Freshwater Mixed Use Development

50 Lawrence Street
Freshwater, NSW

Development Application
SEPTEMBER 2021

LIST OF CHANGES:

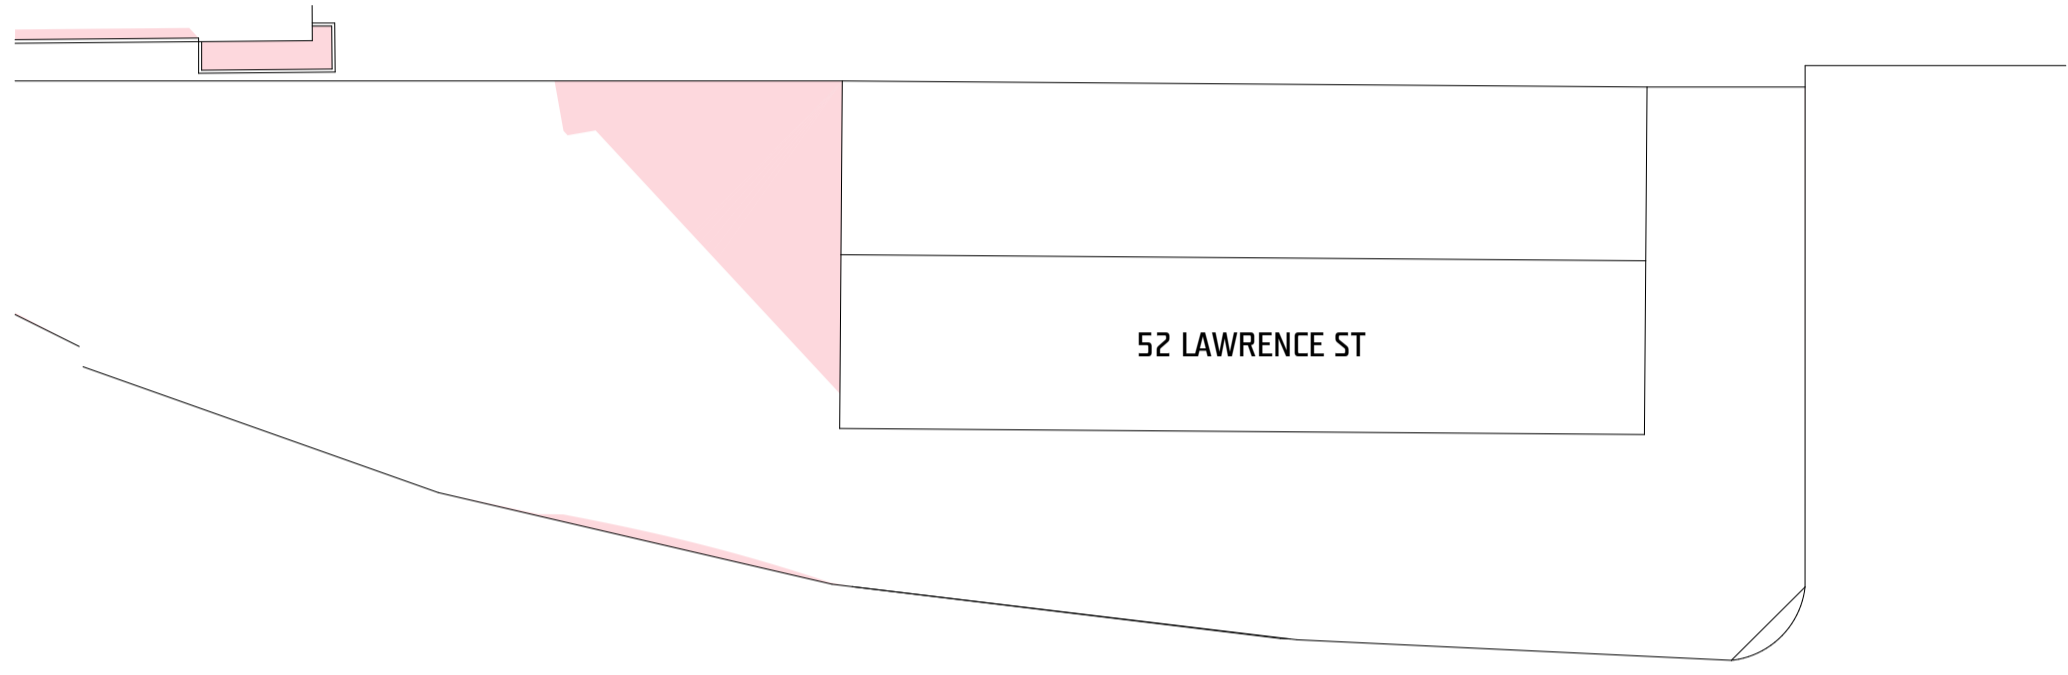
M: Neighbouring Property- Existing garage added to plans for clarity.
